**CITY OF GRASS VALLEY
ENGINEERING DIVISION**

ADDENDUM NO. 3

**SLATE CREEK LIFT STATION PUMP REPLACEMENT PROJECT
PROJECT NO. 17-09**

**PROJECT: SLATE CREEK LIFT STATION PUMP REPLACEMENT PROJECT
PROJECT NO. 17-09**

SLATE CREEK LIFT STATION
PUMP REPLACEMENT PROJECT
CONSTRUCTION PLAN

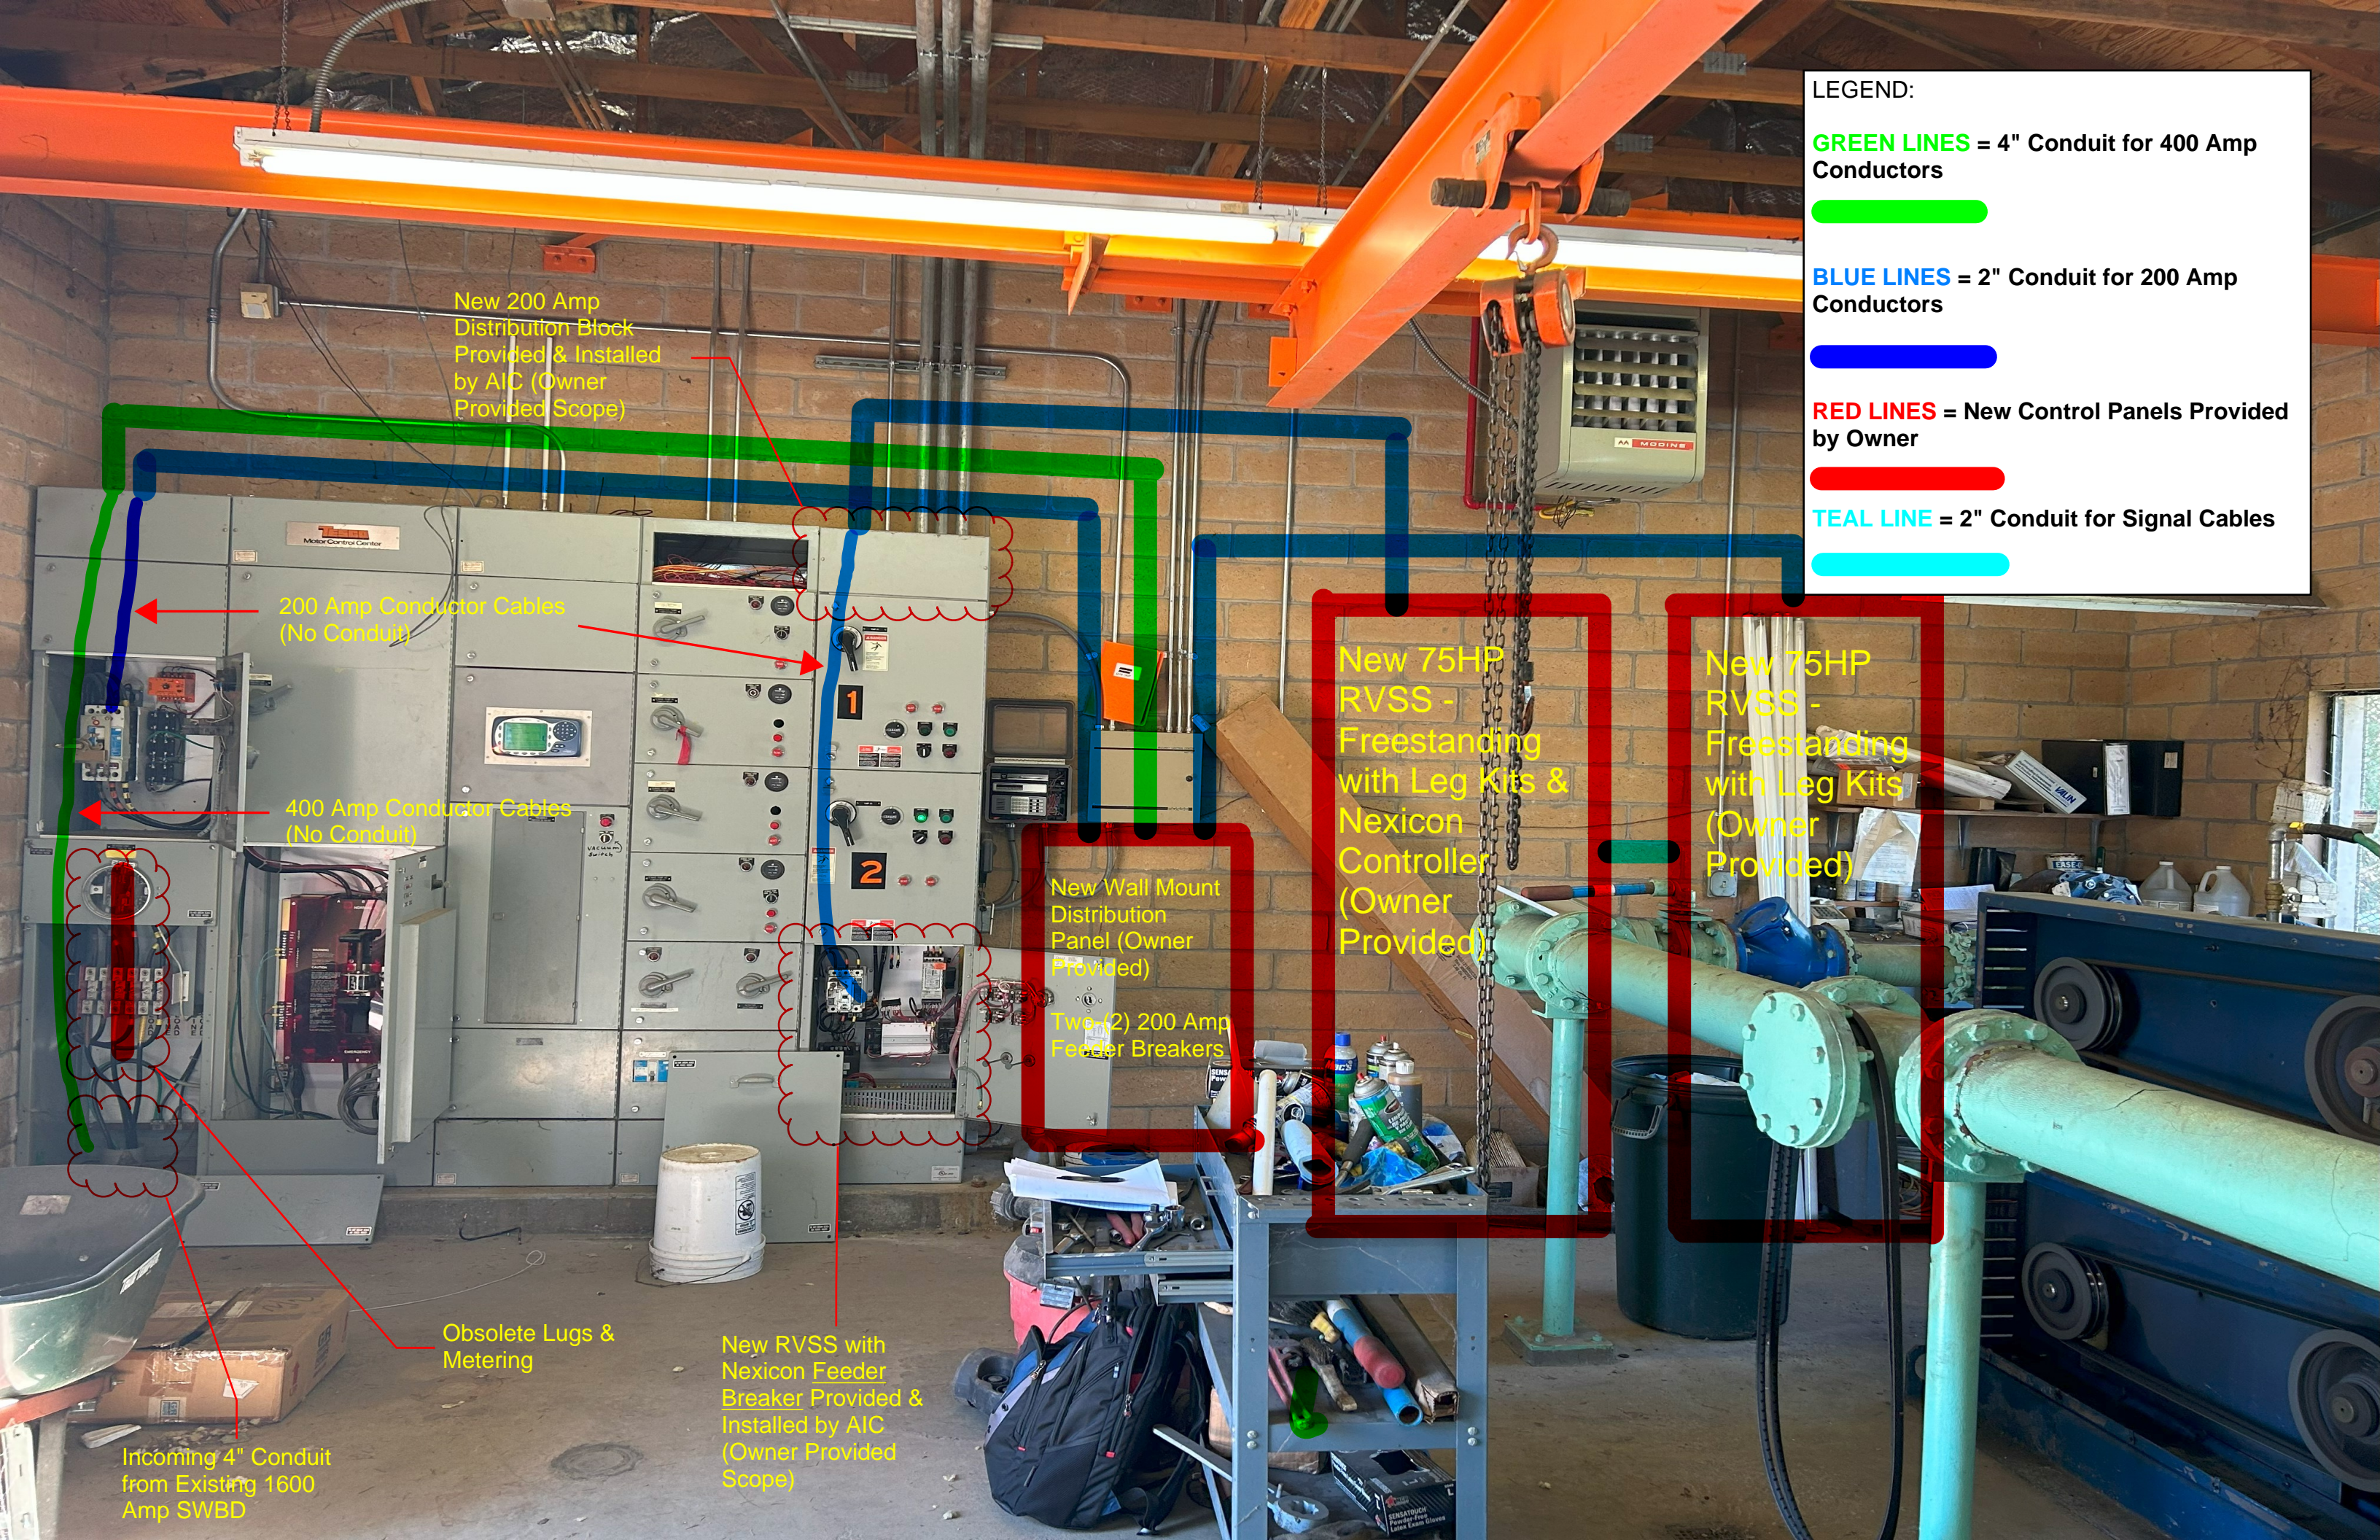
1. Sheet 3 of 6 "Demolition" – the following items shall be modified to as follows:
Item #1 – The items to the right of the existing power cabinet (telephone line/box, unused alarm box) shall be removed to make room for the new distribution panel to be installed.
Item #16 - Remove the existing air tank, water tank, well tank and all associated piping.
2. Sheet 4 of 6 "Construction Plan" – Please see the attached drawing showing additional Electrical Scope information.

Electrical Scope:

Remove Existing 200 Amp Conductors & Replace with 400 Amp Conductors in Existing Conduit (Approximately 125' from Existing SWBD to Connection at New Standalone Distribution Panel)

Overhead Conduit Out of Existing Left Section of MCC to Allow External Connection with New Standalone Distribution Panel

Existing 1600 Amp / 480V SWBD (PG&E) with 400 Amp Distribution Circuit Breaker & Electronic Trip (Currently Set at 200 Amps)
